# **FINAL TMDL Report**

## **Dissolved Oxygen and Nutrient TMDL for Stevenson Creek Tidal Segment, WBID 1567**

**October 2014**

### ***Comments and Department Responses for the 2008 Public Comment Period***

Figure 2.1. DO Measurements in Stevenson Creek Tidal Segment, WBID 1567, During the Verified Period

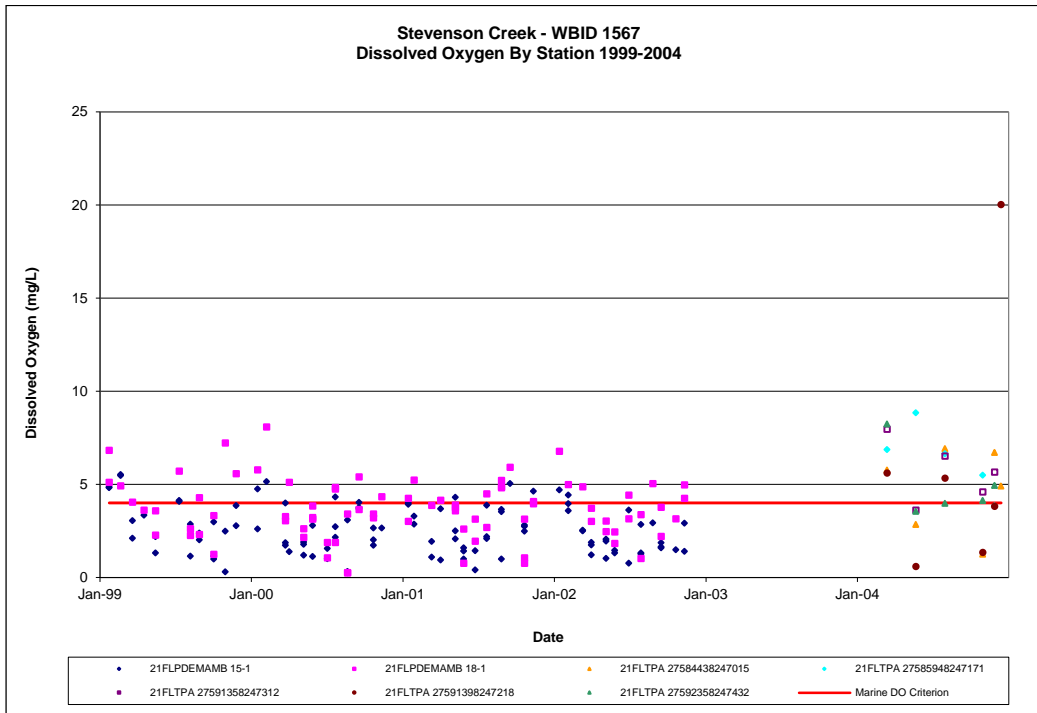
1. Pages 7-8: Table 2.2 shows a summary of DO for 1999-2006 yet Figure 2.1 shows no data collected beyond 2004. The data collected for this TMDL assessment contains 2 heavy rainfall years (2002 and 2004) which could have negatively impacted the overall analysis. Pinellas County staff believes that while there was enough data to satisfy the verified period criterion, more data is needed to unbiased the unusually wet years experienced in 2002 and 2004.

Figure 2.2. Chlorophyll a Measurements in Stevenson Creek Tidal Segment, WBID 1567, During the Verified Period

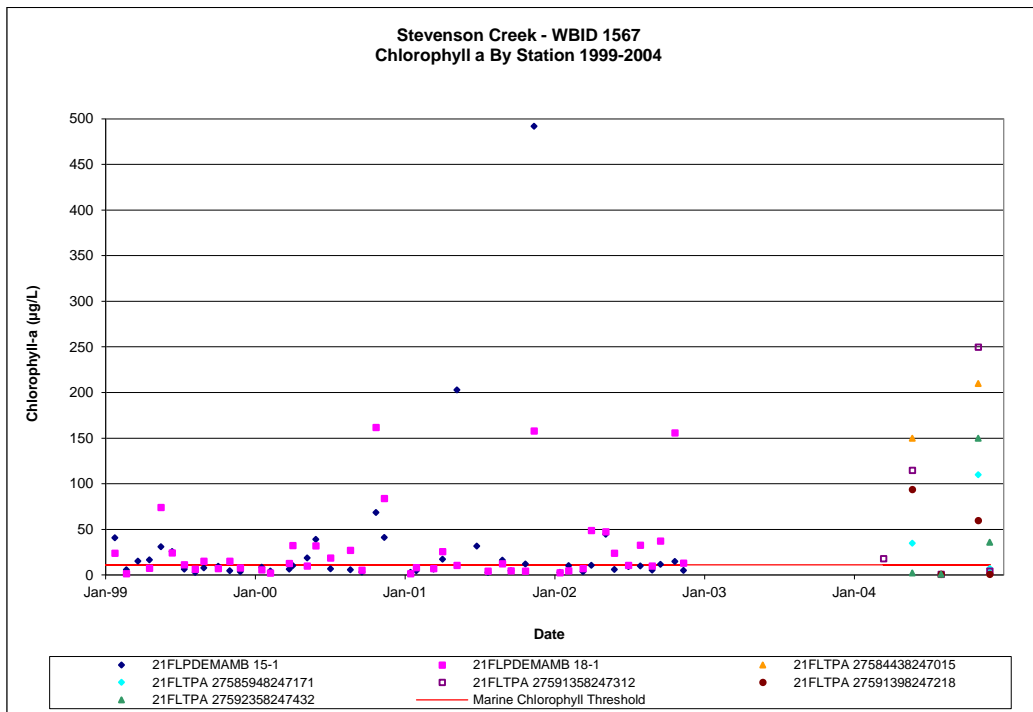
3. Page 8: Figure 2.2 shows Chl-a values of 492 µg/L at site 15-1 and a >150 µg/L at site 18-1 in November 2001. Field notes entered into STORET indicated there was a very strong incoming tide and that the water was very turbid. Based on the state's red tide database, a red tide was occurring during November 2001. This data should be removed and all other outliers verified per IWR rules (item also addressed in 07/07108 letter.)

1. Page 9: Figure 2.2 shows Chla values of 492 µg/L at site 15-1 and Chla >150 µg/L at site 18-1 in November 2001. Field notes entered into STORET indicated there was a very strong incoming tide and that the water was very turbid. Based on the state's red tide database, a red tide was occurring during November 2001. This data should be removed and all other outliers verified per IWR rules (item also addressed in 07/07/08 letter and 12/8/08 letter).

Figure 4.3. *Septic Tank Locations in the Stevenson Creek Watershed*

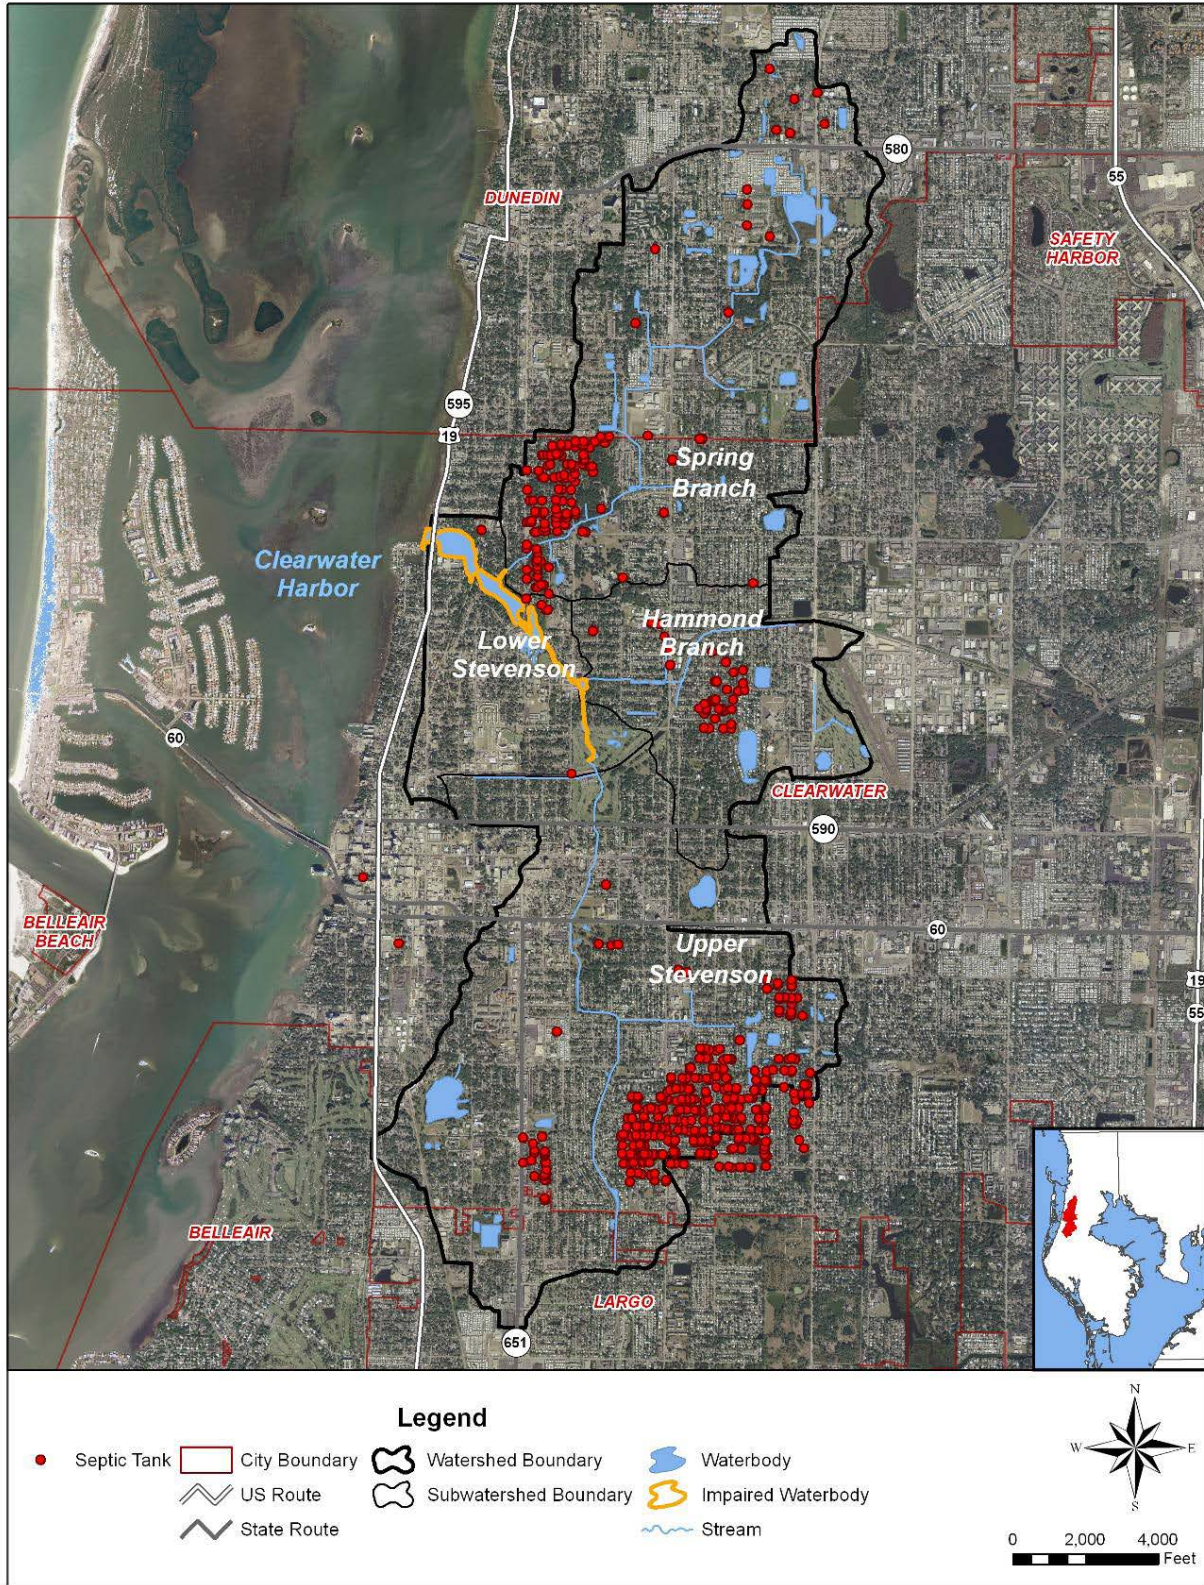
6) Septic Tanks - Septic tanks are mentioned in both reports (draft report Section 4.3.2) as not being a significant source of load since the watershed is 90% built out. Yet, in Figure 4.3, the septic tanks appear dense in some areas. There appears to be inadequate discussion or data presented regarding their potential impact to the TMDL.

2. Section 4.3.2, page 19, states that the incidence of septic tank coverage within the Stevenson Creek watershed is relatively low; however, figure 2-7 on page 2-14 of the modeling report shows a heavy coverage of septic tanks within the WBID and its contributing tributaries.

The Department believes that the best available information was used to evaluate the impact of septic tanks in the creek's watershed. The septic tank locations presented in Figure 2.7 of the modeling report were used in the HSPF watershed model. The septic tanks coverage is that published by the Florida Department of Health. The TMDL report text referring to the low incidence of septic tanks will be removed. Additionally, the modeling report has been revised to provide additional explanation for estimating the pollutant loadings from septic tanks.

2. The septic tank locations presented in Figure 2.7 of the modeling report were used in the HSPF watershed model. The TMDL report text referring to the low incidence of septic tanks will be removed.
